The City of Albany - Manning Boulevard Improvement Project

Final Concept Concerns (2/1/2024):

Manning Boulevard Street Improvement Project

Summary of Comments/Responses Manning Boulevard Public Meeting Held on August 14, 2023

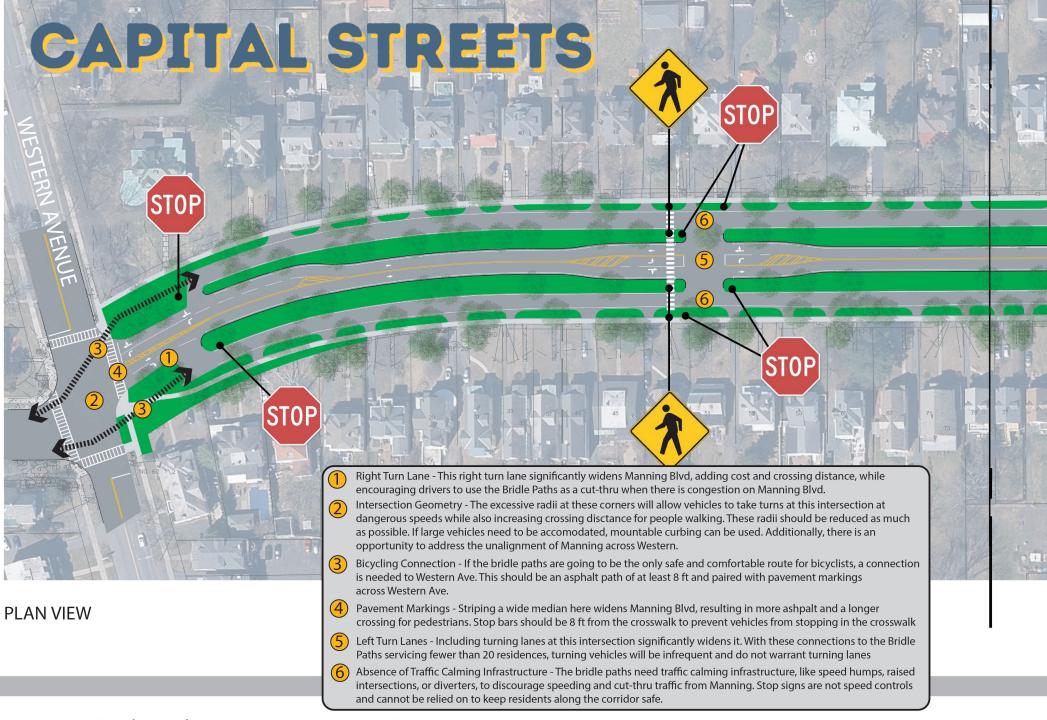
- Bridle Paths
 - No traffic calming infrastructure is included, allowing speeding and the use of the bridle paths as cut-throughs to continue
 - New right turn lane on Manning (near Western) will encourage bridle paths to be used at cut throughs

- No direct bike connection from Western or Washington, so cyclists will need to use the busiest sections of Manning to access the bridle paths, which is clearly more dangerous

- Manning's Intersections at Western and at Washington:
 - The existing excessively large corner radii appears to be unchanged. This makes the intersection more dangerous, especially for people walking, by:

- Allowing vehicles to take turns at high speeds
 - And making the crossing distance for pedestrians longer, leaving them in the roadway, where they are vulnerable to traffic, longer

- A striped median is shown at both ends of the corridor. This should either:
 - Be eliminated, to decrease the width of the roadway, or
 - Made into a larger, concrete pedestrian refuge island

- No bicycle infrastructure
 - This ignores the City's 2021 Bicycle and Pedestrian Master Plan, which highlights the importance of Manning Blvd as a connector and calls for buffered or protected bike lanes

- The Manning Blvd Improvement Project instead looks to put bicyclists on the bridle paths, yet does not give bicyclists a direct connection from the bridle paths to Washington or Western Avenue

- The use of the bridle paths as low stress routes only makes sense if they are accessible without putting cyclists back onto Manning Blvd before the intersections at Washington and at Western, the most dangerous areas for any roadway user. It also is only realistic if the bridle paths include effective traffic calming measures to physically prevent speeding

Conclusion: This project does very little to improve safety and noise along the corridor
